Submissions Report

Alterations and Additions to
St Philips's Christian College,
Cessnock

Prepared by Barr Planning

This Submissions Report supports State Significant Development Application SSD-10360337. The development proposal is for the alterations and additions to St Philip's Christian College, Cessnock Campus.

Figure 1: Amended roundabout design, Northrop 2022

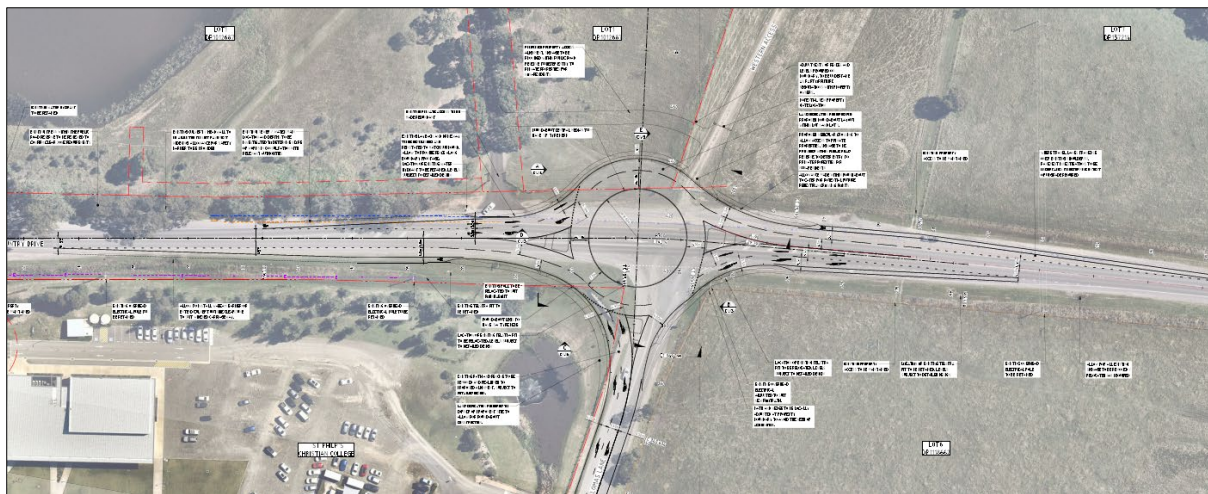
Comments from TfNSW in relation to the provision of two lanes and deflection to aid traffic movement and safety were applied to the roundabout design, shown in Figure 1 below. The proposed roundabout design has been developed to accommodate a B-Double undertaking a U-Turn.

The amended roundabout design shows that the implemented recommendations results in significant increase to the size and scale of the roundabout. Consequently, the roundabout encroaches on to private property, meaning land acquisition is required to facilitate the intersection upgrade. Given the current concern surrounding adequate access to property as a result of the intersection upgrade an alternative solution has been considered. **Figure 2** demonstrates the proposed layout of a signalised intersection.
